Committee: Cabinet Member Report

Date: 9th March 2016

Subject: Proposed MP1 CPZ ext (Cranleigh Road Area) Merton Park – formal consultation

Appendix 1 – Drawing No. Z78-224-02

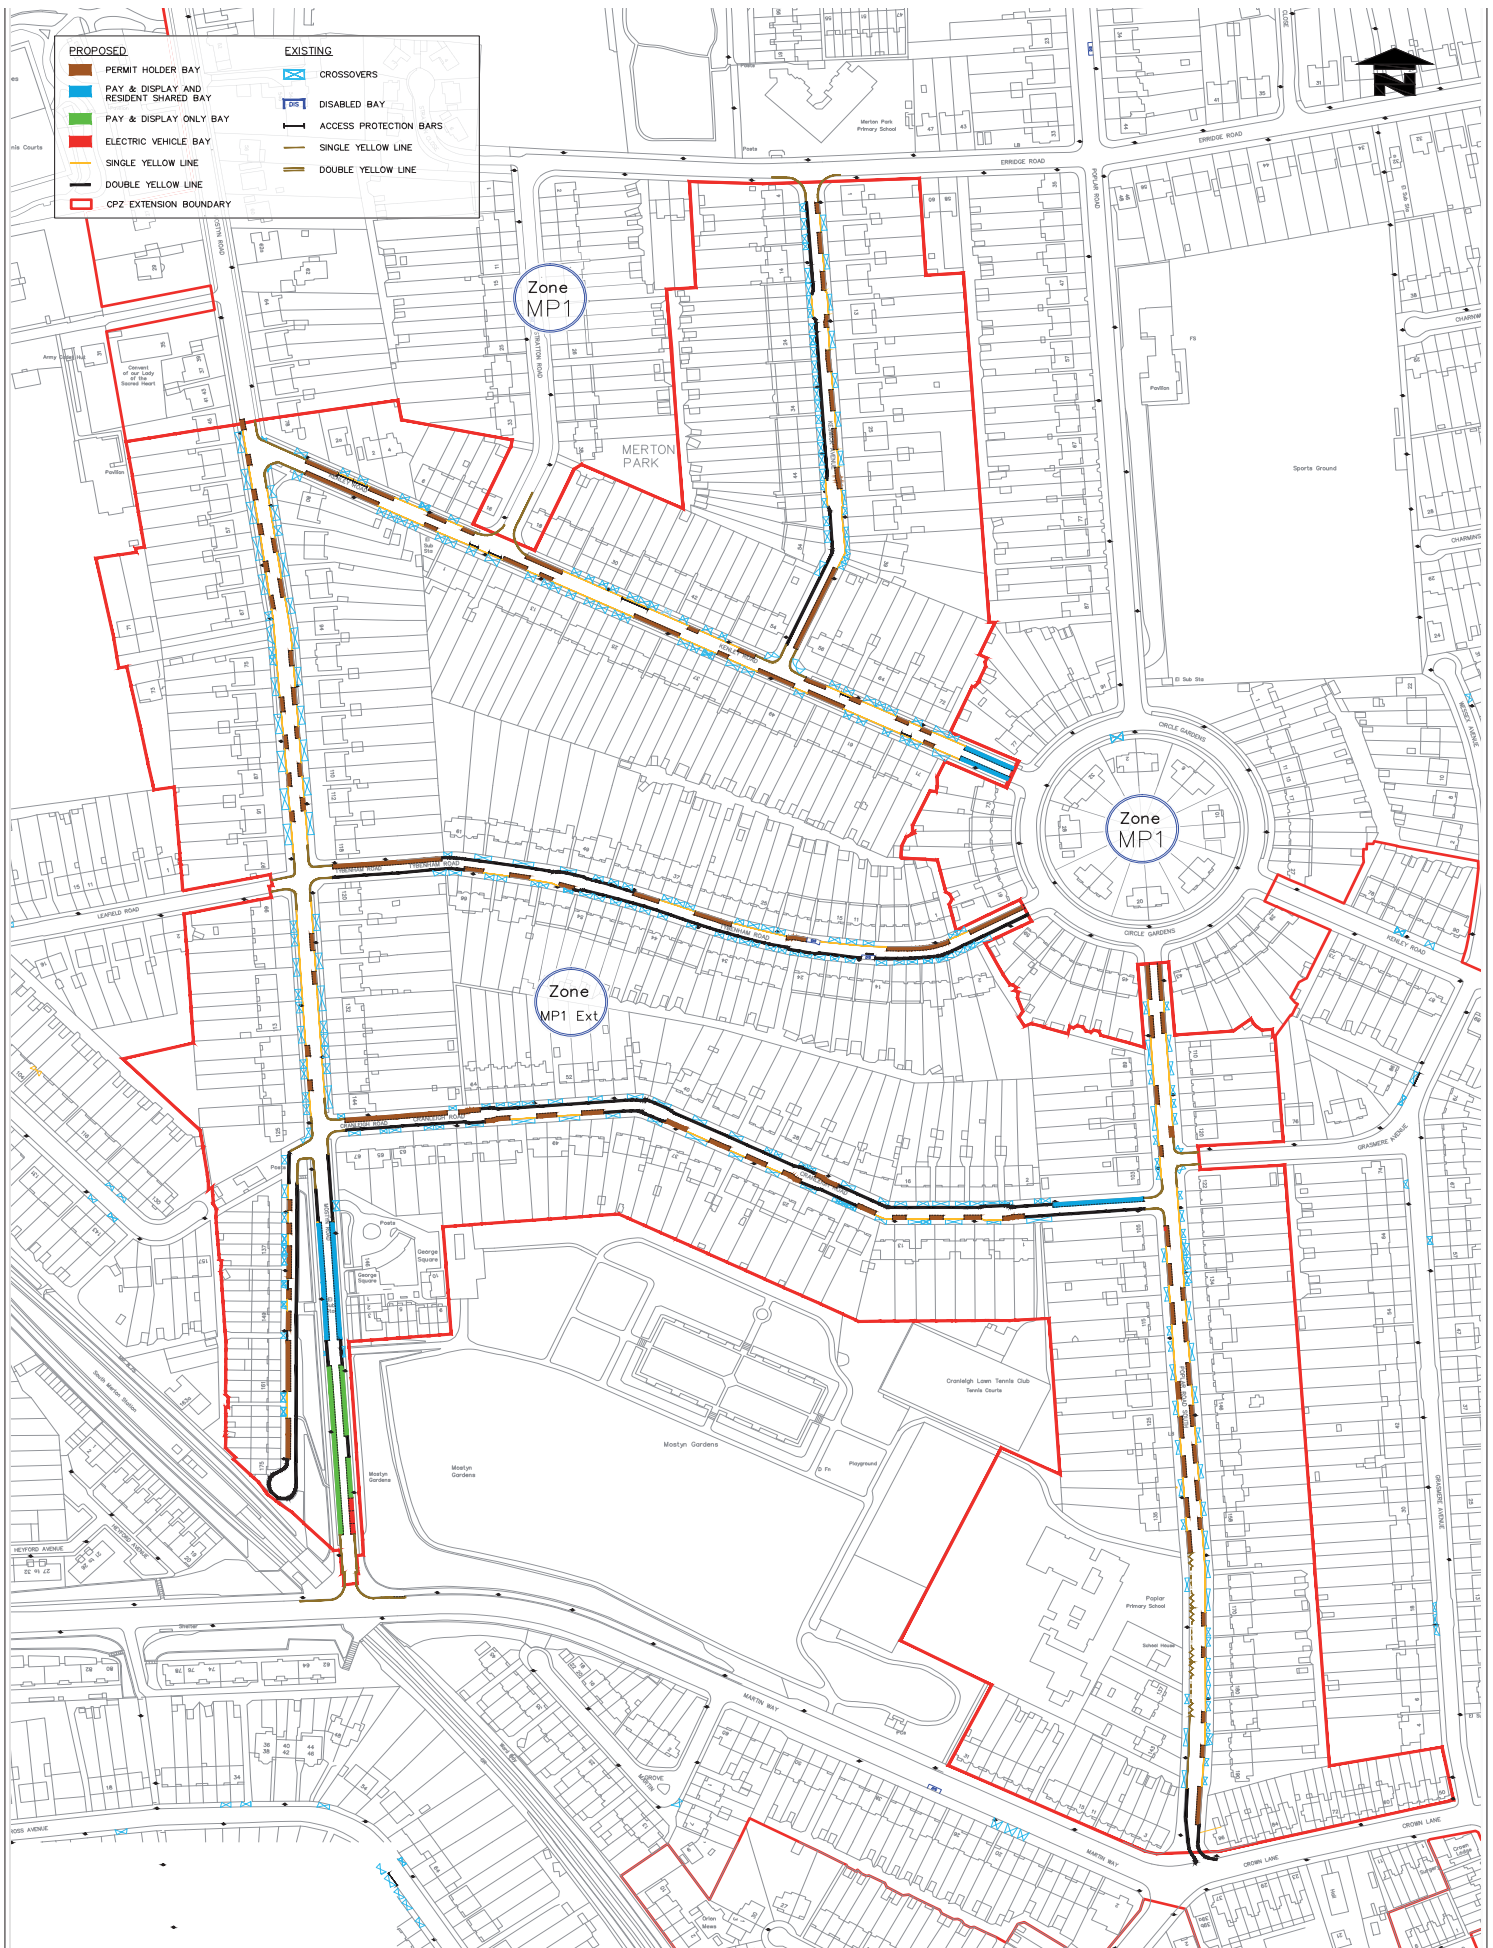
Cranleigh Road has 68 crossovers, and although difficult to interpret on the plan, the proposed provision is for about 47 parking spaces and two bends. However, it is proposed to put a double yellow line all the way down the north side of the road which would be active for 24 hours a day 7 days a week.

The printed plan distributed to all households showing the proposed parking layout was so small it was not possible to differentiate between single and double yellow lines. The on line version had to be significantly enlarged before a wide single yellow line was then correctly seen as a double. Many of the residents are old, do not have PC's, easy access to the internet or have poor eyesight. Consequently, we feel the parking proposal, at the very least, could have been misrepresented and should not have been used to canvass the scheme or form opinions. Once again we believe that this calls into doubt the process being used and why this letter should be treated as yet another one of complaint.

It is suggested that between numbers 4 to 14 inclusive there is no need for any change to the current situation. However, the proposed plan shows double yellow lines the whole way down the even numbered side of the road. A crossover, under clause 243 of the Highway Code, restricts parking without the owner's permission but allows setting down or picking up passengers. It therefore seems draconian to move from a local system that has not had

- 4.7 The plan on the consultation leaflet was reduced to fit into A3 paper space which is normal practice and as a result, design details especially the double yellow lines appear small and possibly somewhat difficult for some residents to differentiate between single and double yellow lines. However, within the consultation leaflet residents were advised to contact the Council if they want to inspect larger plans and that the consultation leaflet and plans were also available at the Council's front desk (the Link) and on the council's website and a link was provided within the leaflet for residents to view the details online.

In conclusion, officers' recommendation is to implement the double yellow lines as consulted upon which is normal practice within all parking management proposal. Within any parking management arrangement, the Council gives priority to maintaining access and safety at all times and not just during specific times. Parking can only be permitted where it does not impede on access and passing gaps are also used to make sure vehicles have some where to pull in to give way to oncoming traffic. Reducing the restrictions from double to single yellow lines or using alternative design would pose an unacceptable risk.

Appendix 4 – Letter from a resident + Drawing of resident design

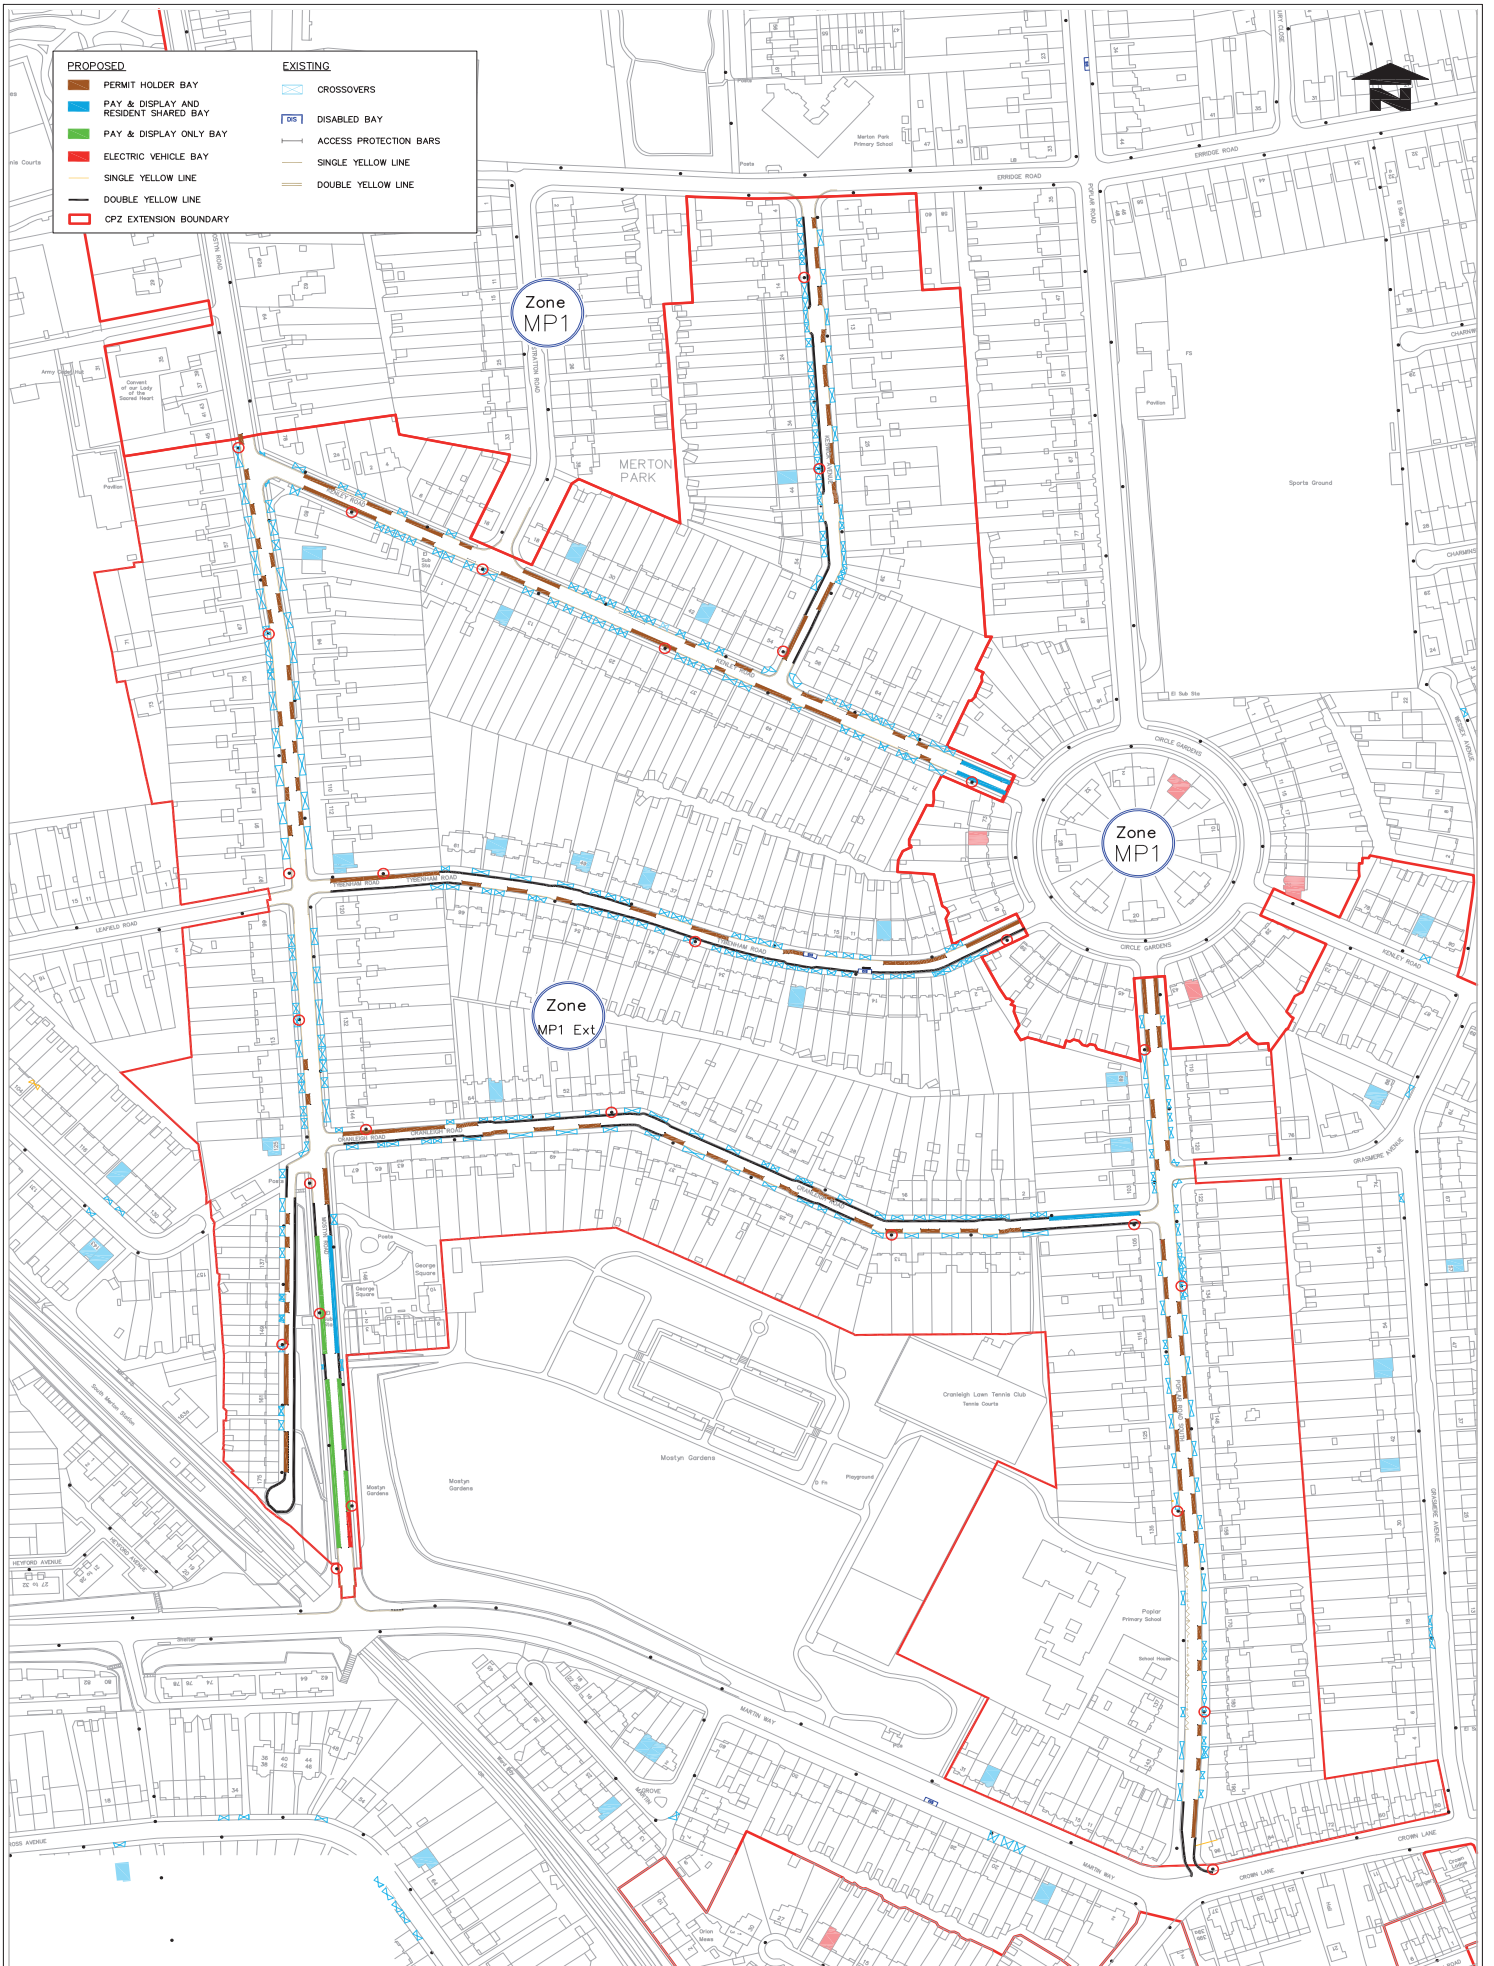
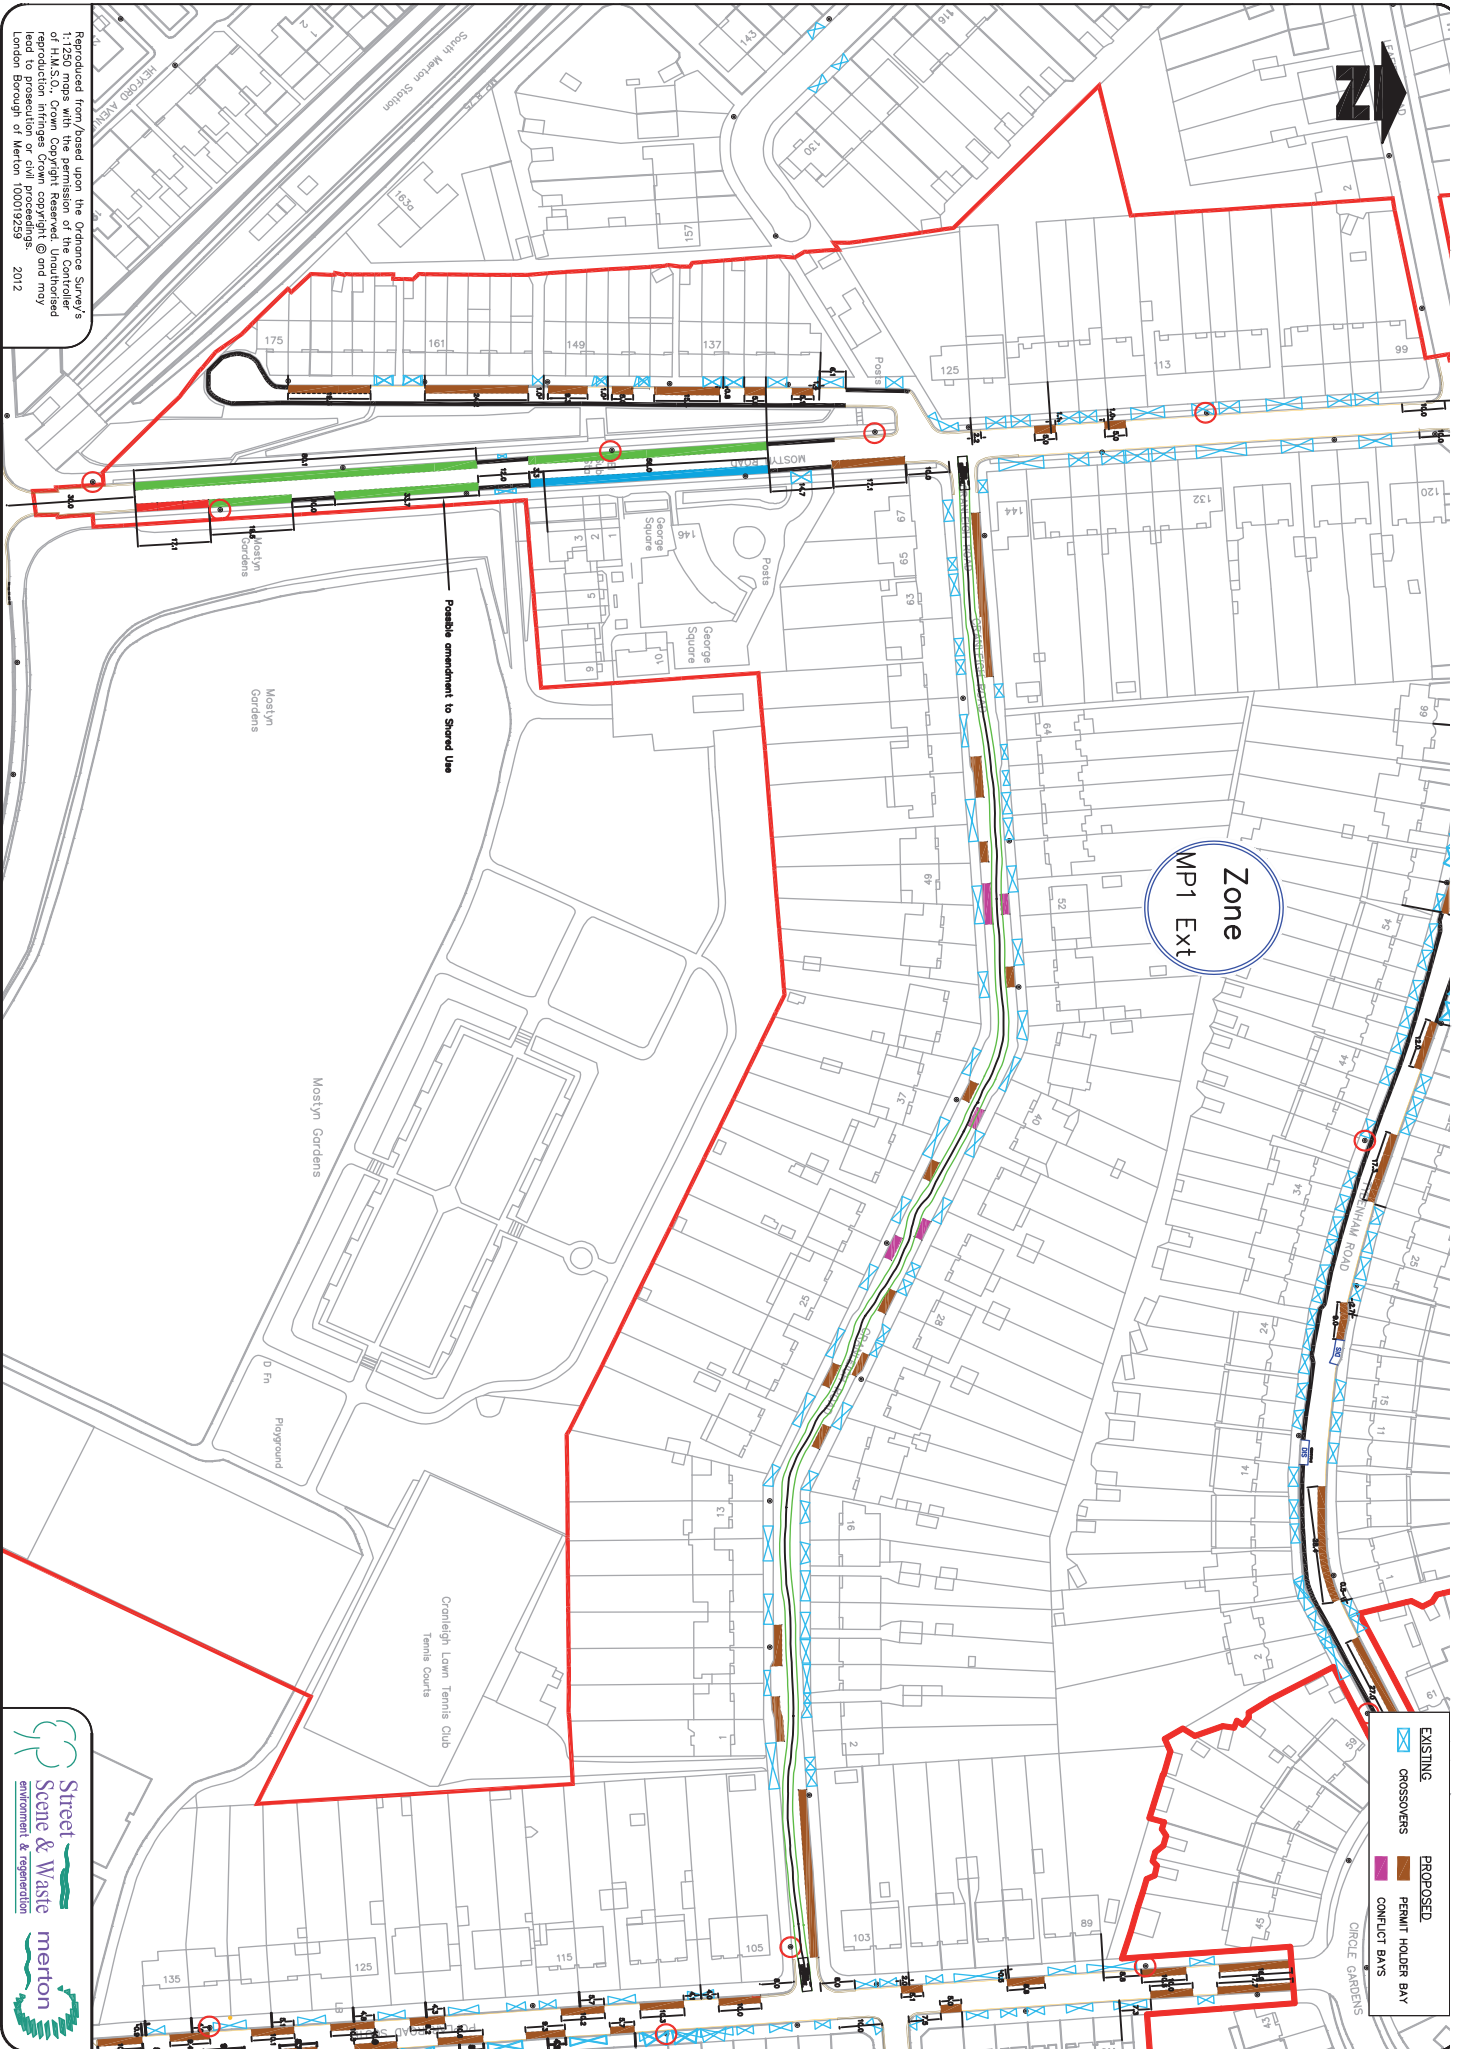
Daybrook Road has 43% parking bays to the number of crossovers whereas in the Cranleigh Road proposal it has 69% showing that the difficulty in allocating parking bays in Cranleigh Road is not a significant problem. Therefore, by reducing the number of parking bays in Cranleigh Road slightly from 47 to 41 it would be possible to produce a scheme that had the parking bays strategically placed either side of the road but not opposite each other. From our survey we suggest the positioning of single parking bays outside the houses as detailed in Table 2.

Given that Cranleigh Road is approximately 6.4 metres wide for most of its length, alternate parking bays, not opposite each other either side of the road and with sufficient distance between them would comply with Mr Atie's requirement for fire tender access the whole way down the road. Given that a large car could be up to about 1.9 metres wide there would be width of 4.5 metres available which is an additional 1.0 metres over and above your upper minimum limit of requiring a running width of 3.5 metres.

Table 2 detailed locations where residents would like staggered parking arrangement and single yellow lines opposite. The locations of the proposed bays were used to populate a drawing of the road. The drawing is attached as Appendix 4. The drawing was then tracked with a model of fire tender which has a width of 2.45 (new ones have width of 2.55) metres. The result is that the fire tender was unable to access the road where parking bays were either opposite each other or do not have enough gap for a fire tender to manoeuvre between the two sets of bays without damaging parked vehicles. This also means that outside the hours of operation residents can potentially park across their driveways in the evenings and weekends opposite the parking bays. This is the heart of the issue (resident spear heading the objections wants to retain the ability to park on the single yellow outside the hours of operation of the zone) which the Council must guard against to maintain clear access at all times. The Council's stance is that obstructive parking is an obstruction regardless of who is causing it or time of obstruction.
